ADDENDUM NO. 03

CITY OF SAN ANTONIO
TRANSPORTATION & CAPITAL IMPROVEMENTS

PROJECT NAME: **36th St. Ph. IIIB (Billy Mitchell-Gen. Hudnell)**

TCI PROJECT NO: **40-00287**

ILSN SIGN DETAILS
(ILSN–1)

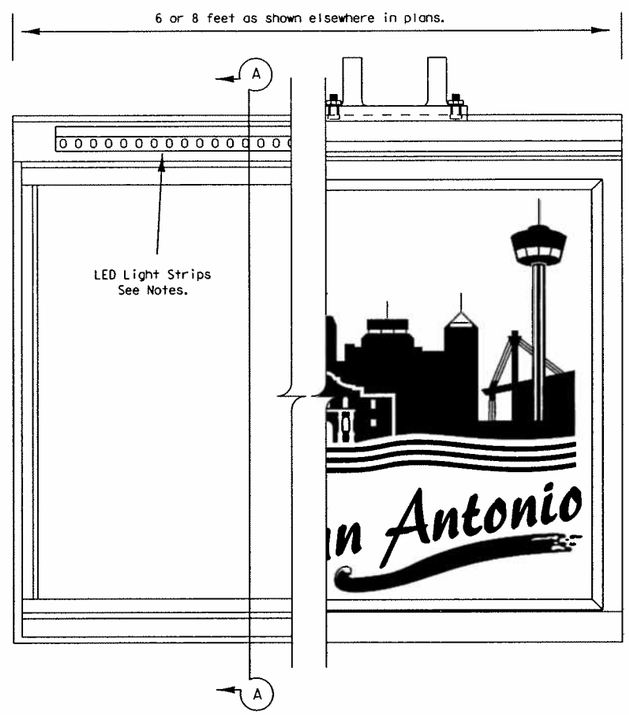
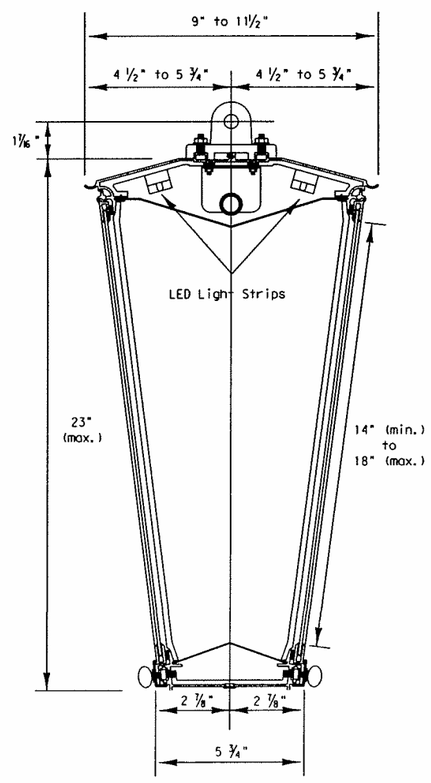
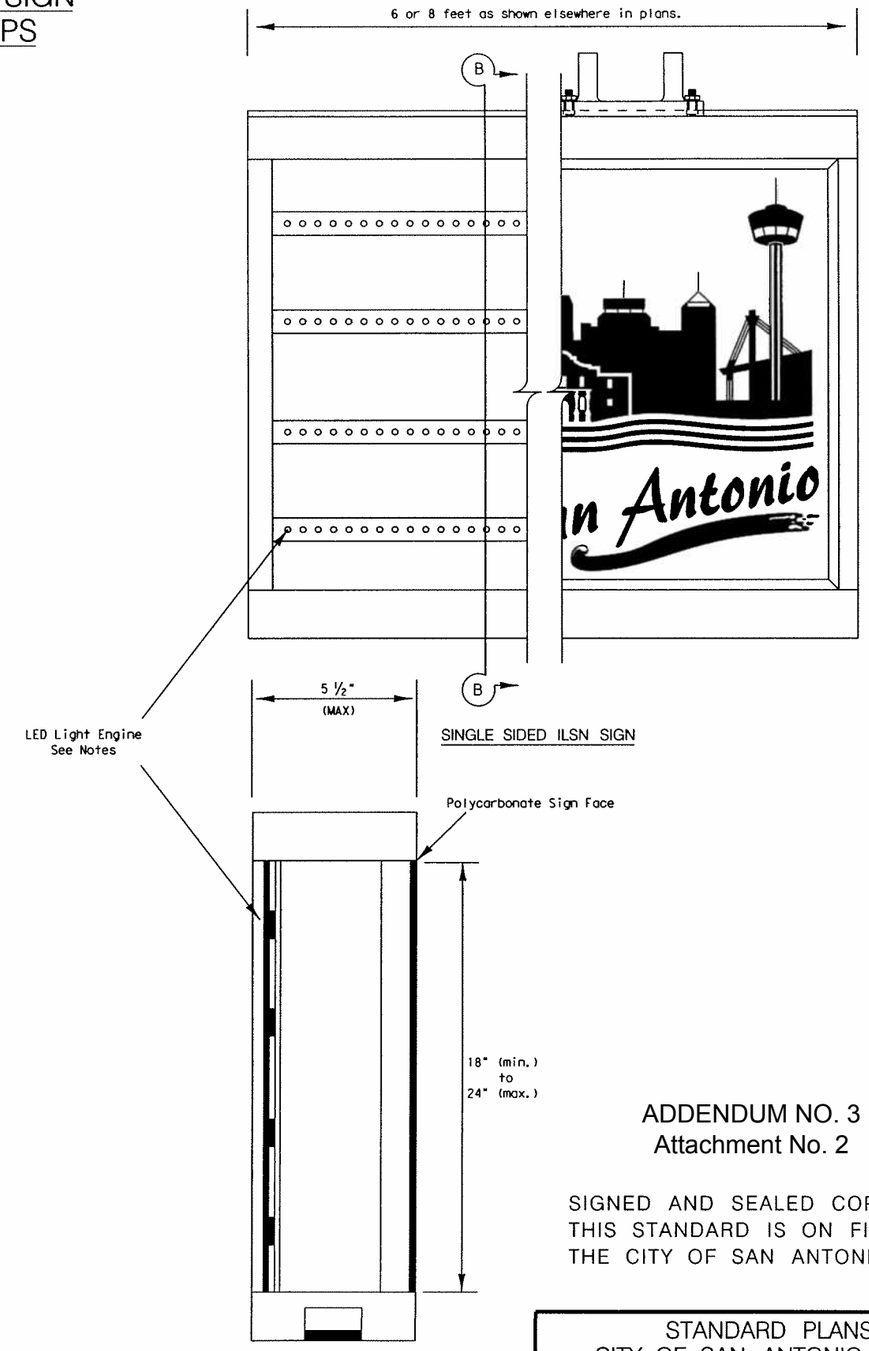
7. Insert Plan Sheets titled ILSN Sign Details 1 of 3 thru 3 of 3 as plan sheets 180A thru 180C, added as Attachment No. 3.

1. Eight foot ILSN sign shall not exceed 16 sq. ft. effective projected area (EPA) and shall not exceed a weight of 85 lbs.
   Six foot ILSN sign shall not exceed 12 sq. ft. EPA and shall not exceed a weight of 70 lbs.
2. Sign message shall be as shown elsewhere in the plans.
3. See Special Specification, "Internally Lighted Street Name Signs" for additional details.
4. Actual sign housing may change with vendor.
5. LED Light Source locations may vary by manufacturer. Power requirements and light output levels of specificaiton shall be satisfied.

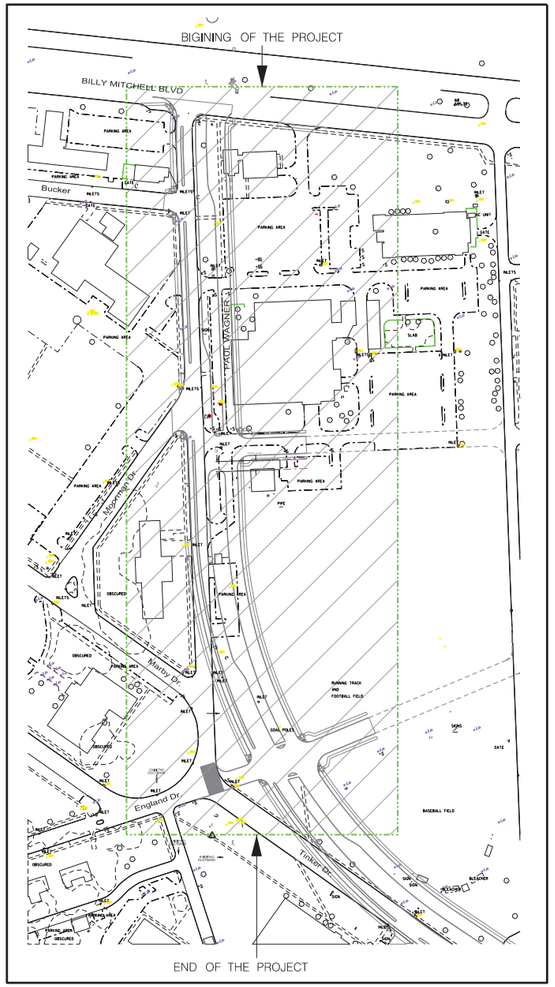
13. Remove and replace plan sheets 231-234, CPS Electric Sheets 1-4, See Attachment No. 3

THIS PAGE REVISED
DESTROY COPIES OF THIS PAGE WITH DATE PRIOR TO:
3-13-15 REVISED COVER PAGE DRAWING TO INCLUDE FILL SCHEDULE AND REVISED PAGE 3 OF 3 DUE TO TEXT MODIFICATION ON DUCTLINE DETAIL.

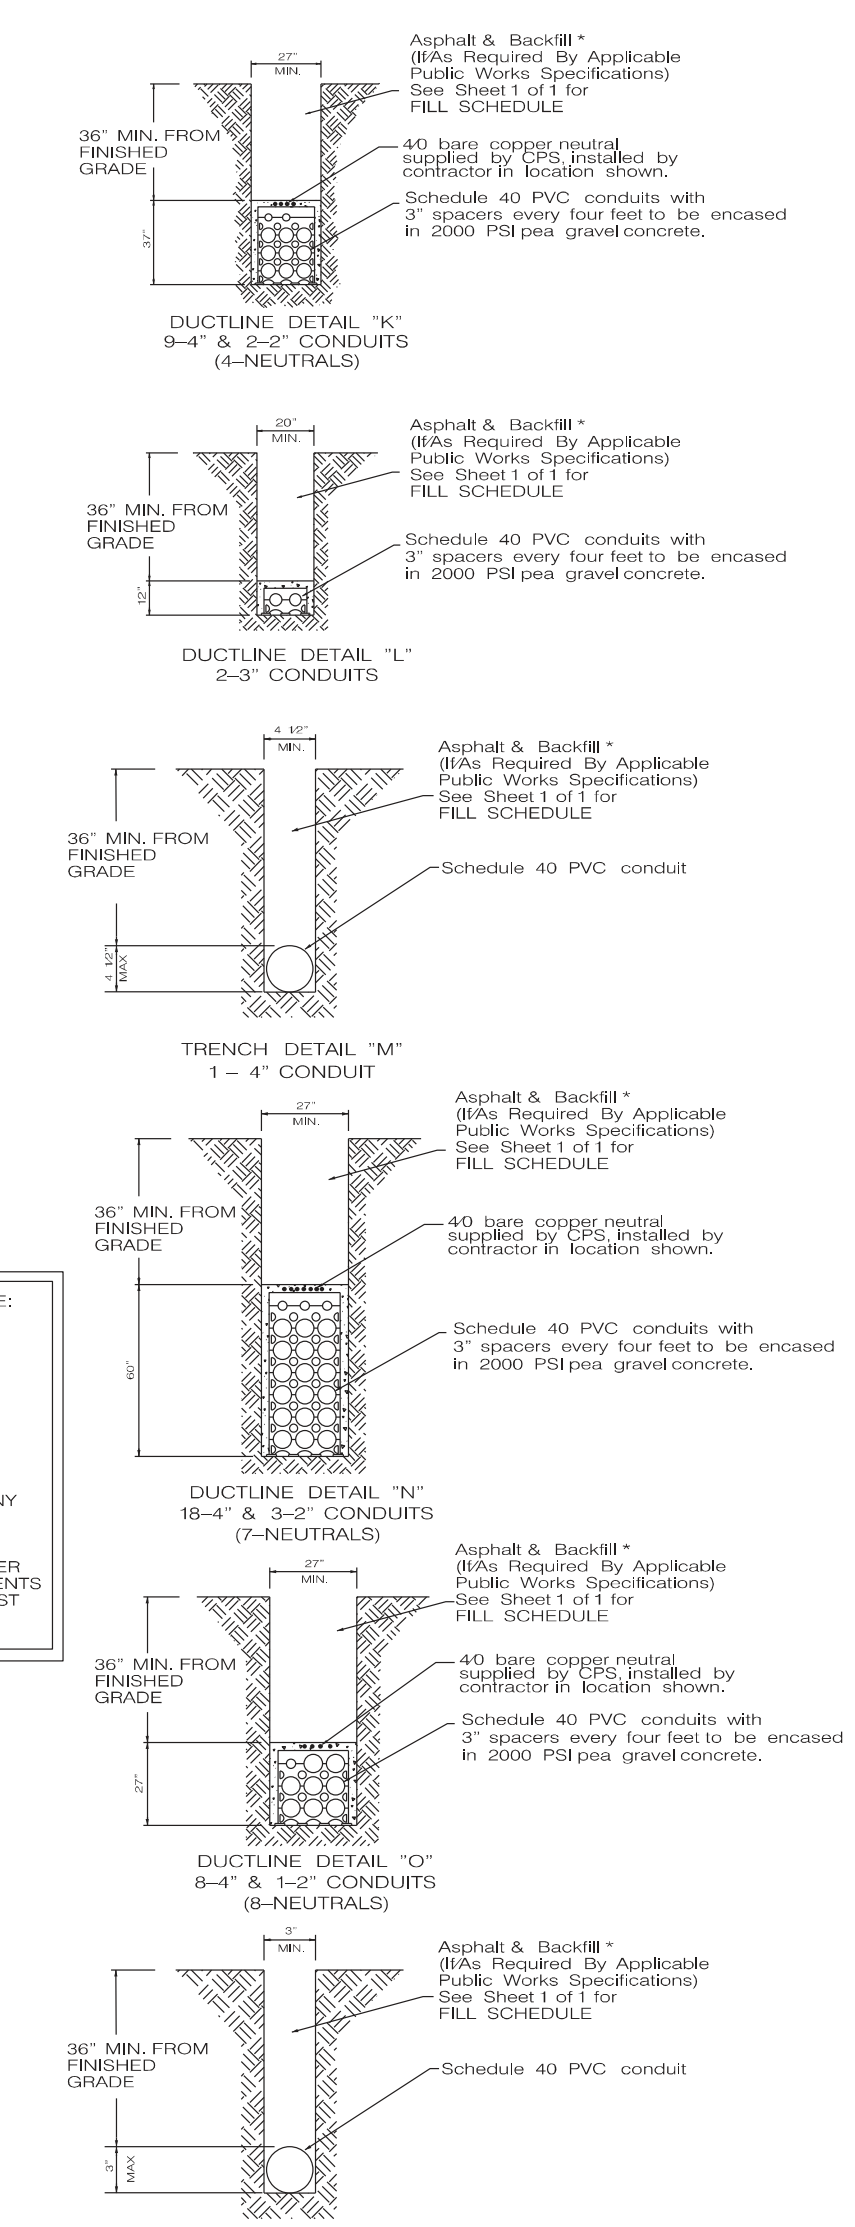
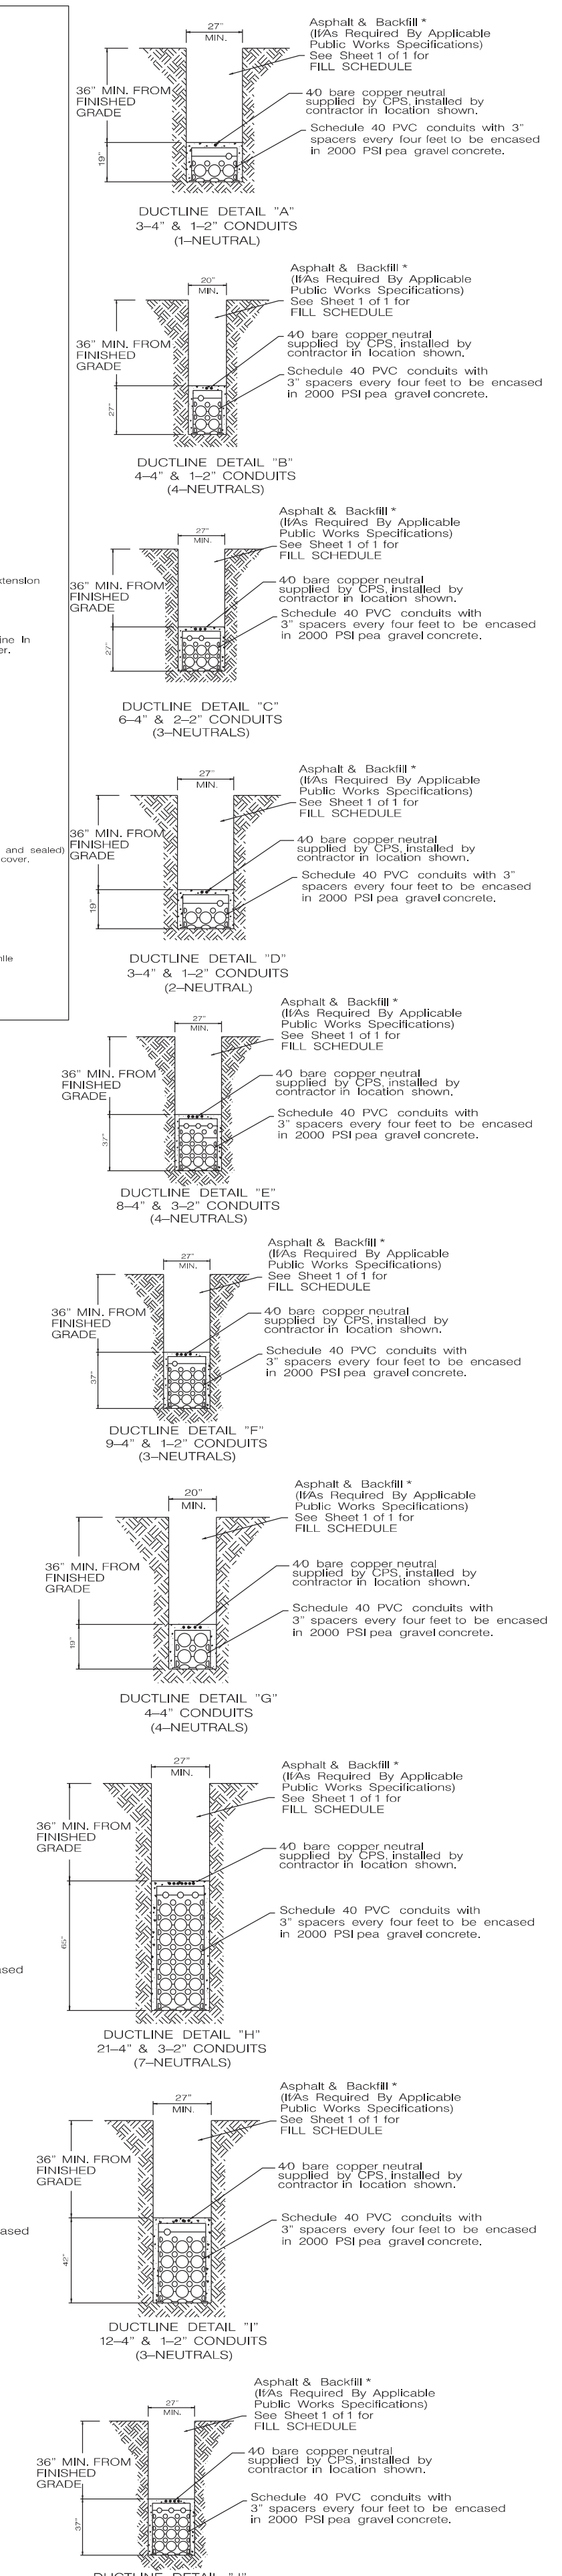
1) Modify Exhibit A Drawings 1-15 on PDF pages 483 thru 497 to be consistent with ductline details shown on the Plan Sheet Drawing Page 3 of 3, PDF page 234.

2) Remove bottom note on Exhibit A Drawings 1-15 indicating "*36" MINIMUM COVER AND FLOWABLE FILL BACKFILL REQUIRE FOR ALL CONDUITS IN PAVE AREA".

THIS PAGE REVISED
DESTROY COPIES OF THIS PAGE WITH DATE PRIOR TO:
3–13–15 REVISED COVER PAGE DRAWING TO INCLUDE FILL SCHEDULE AND REVISED PAGE 3 OF 3 DUE TO TEXT MODIFICATION ON DUCTLINE DETAIL.
